TUBELITE®

Engineering Bulletin: **10122012**

Subject: **P3610,P3620,P3710,P3720 Lever Trim Replacement**

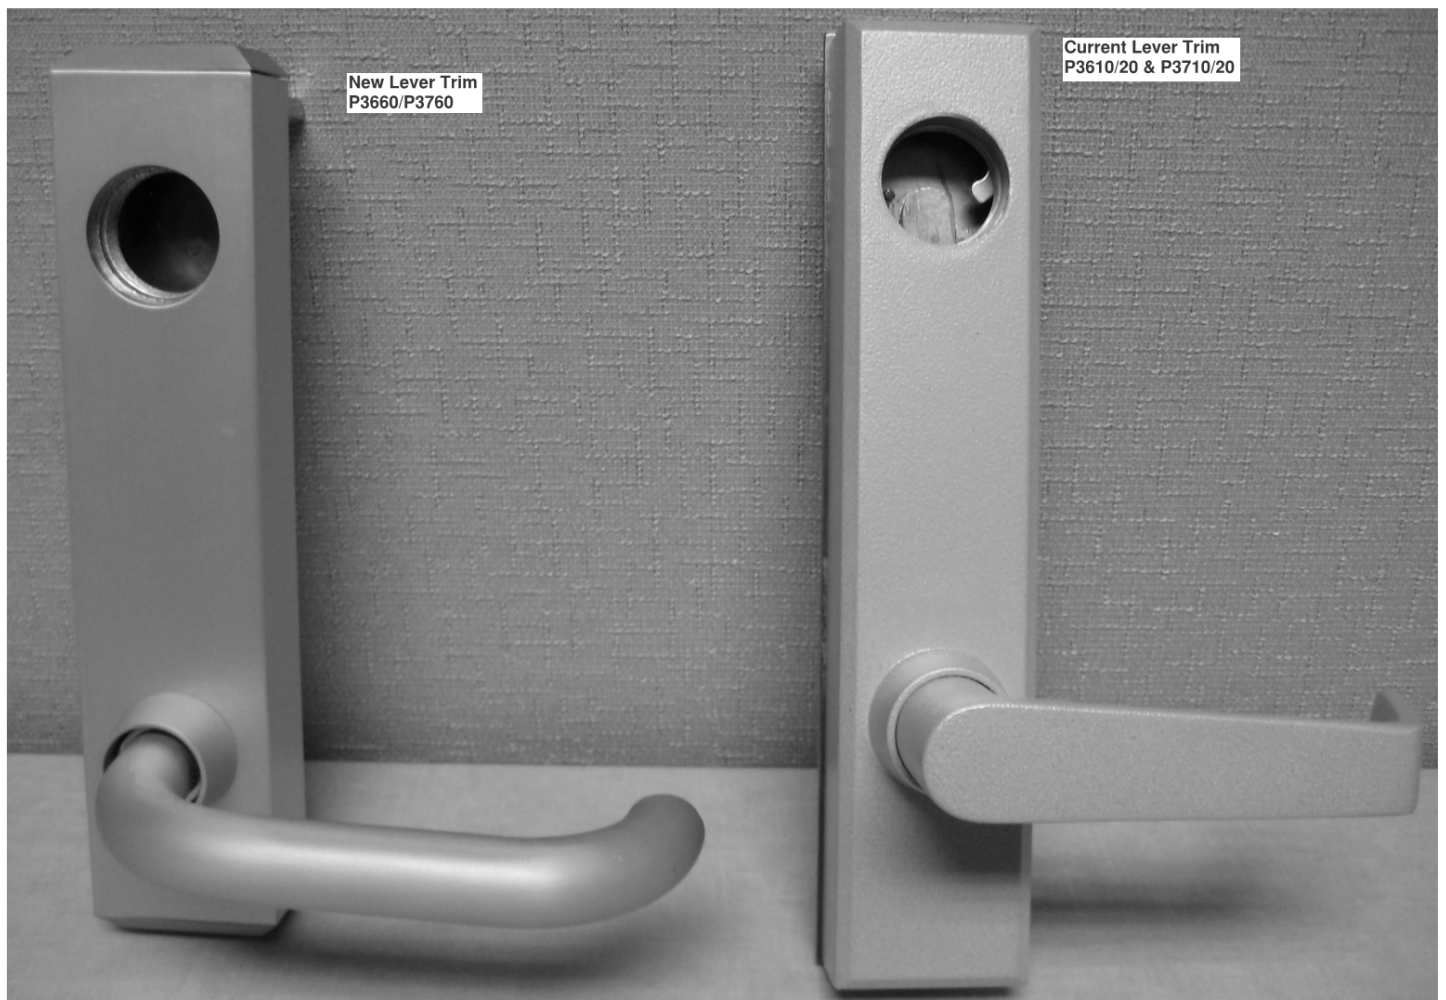
Description: Effective immediately, the standard lever handles for touchbar exit devices have been replaced with new lever handles P3660 and P3760. The new lever is 1 7/8" x 8 5/8" and will require new prep/mounting locations on the door. Product functions and List Prices remain the same.

P3660L/R lever handle for use with P3692 CVR Panic.
P3760L/R lever handle for use with P3792 Rim Panic.
